Addendum No.: 2

York Correctional Institution Central Plant and Piping Distribution

BI – JA – 465

The following clarifications are applicable to drawings and specifications for the project referenced above.

CENTRAL PLANT PLAN INSTALLATION PHASE 1

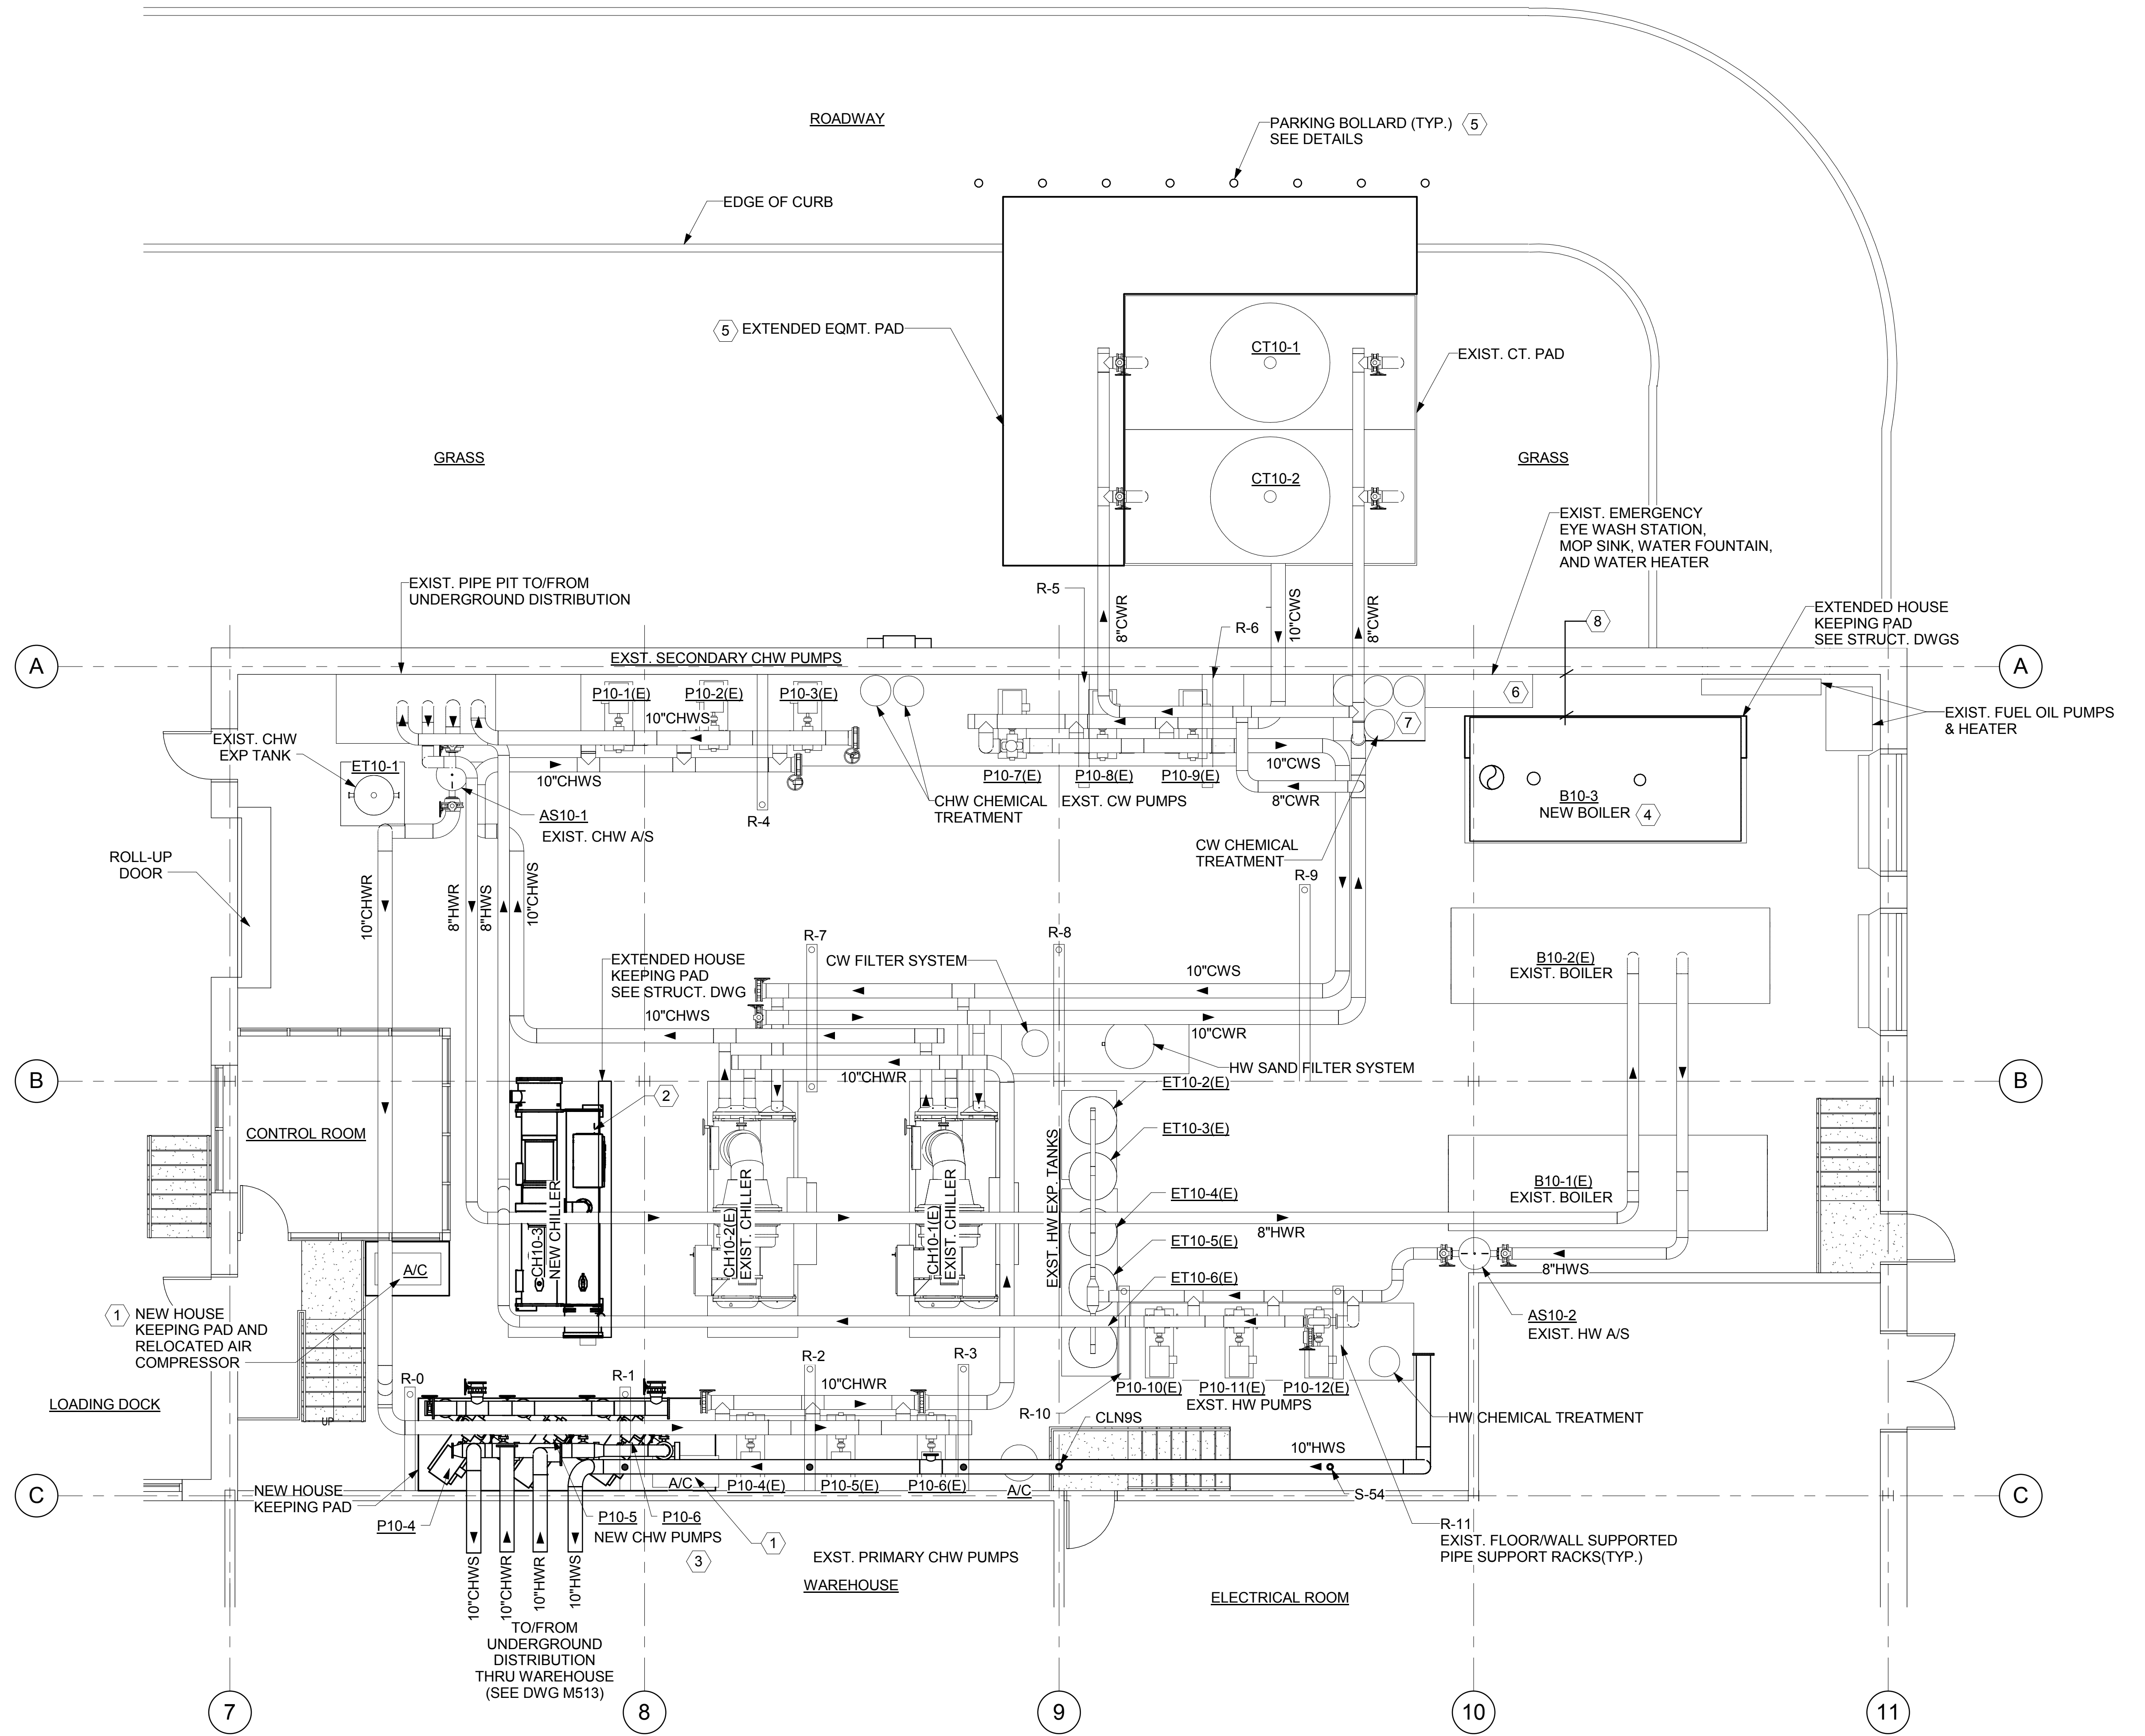
Drawing M501 Central Plant Plan Installation Phase 1

REPLACE the entire drawing with the attached.

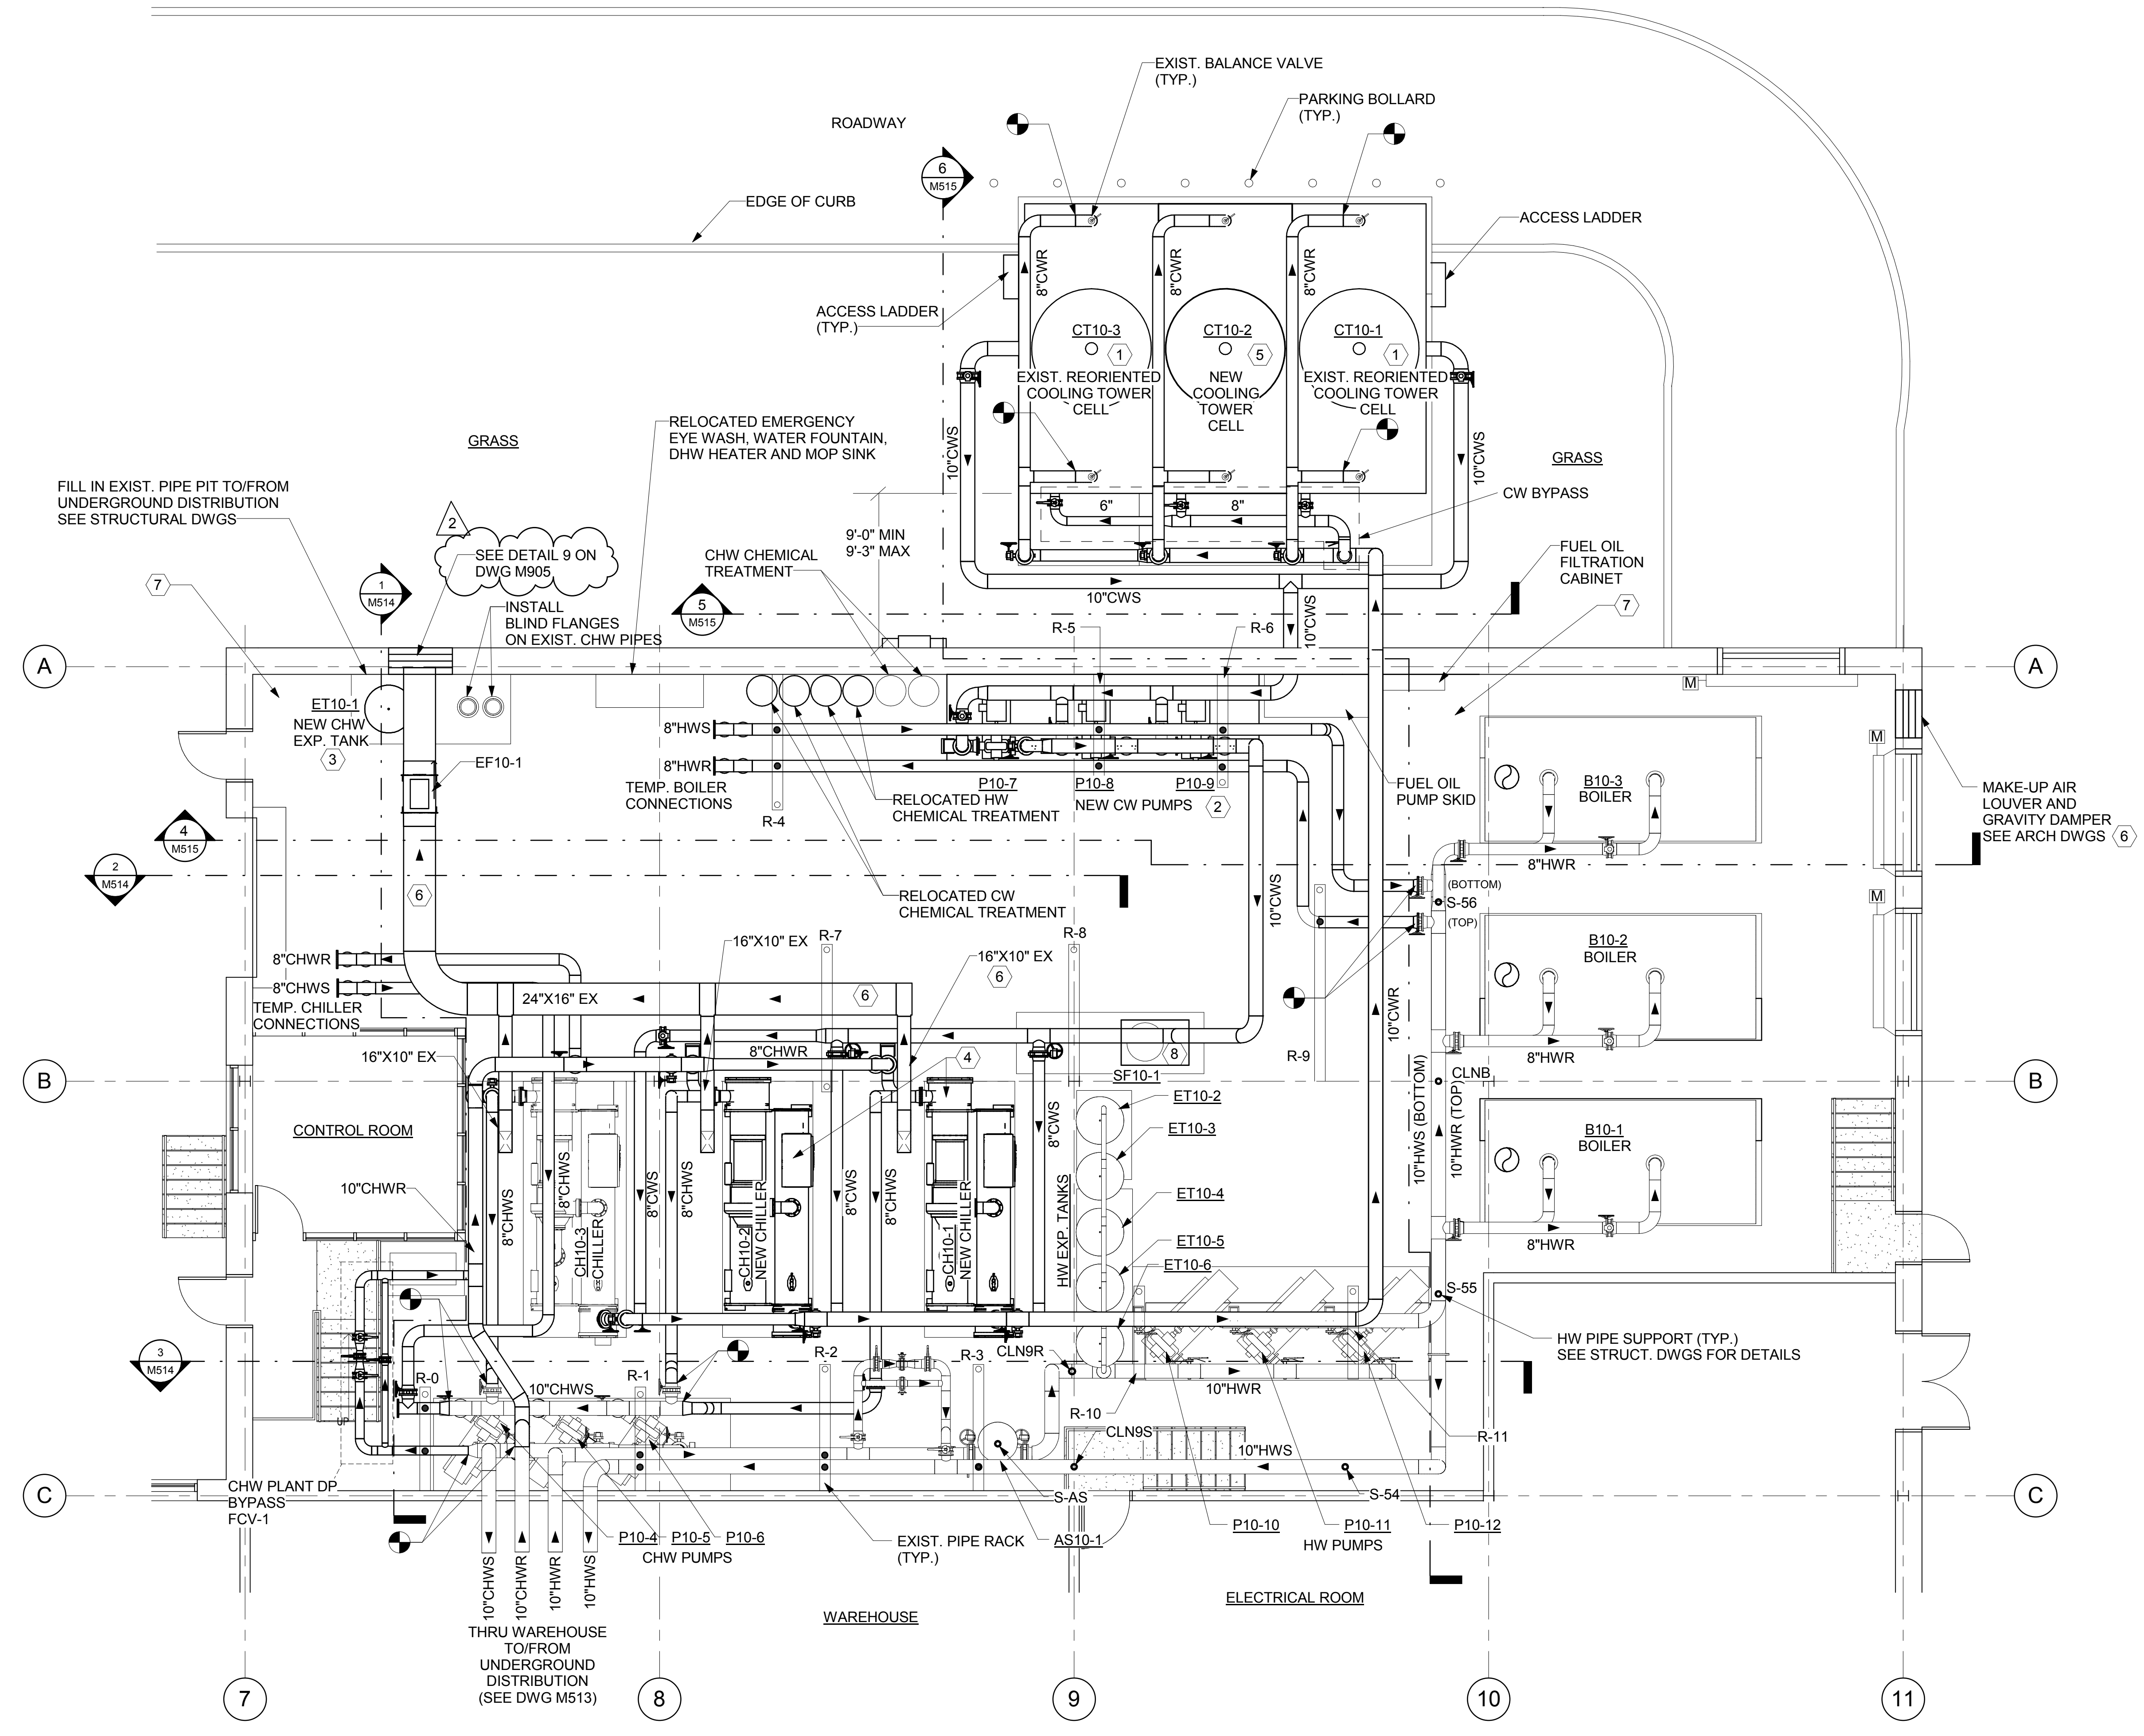
Drawing M505 Central Plant Plan Installation Phase 5

REPLACE the entire drawing with the attached.
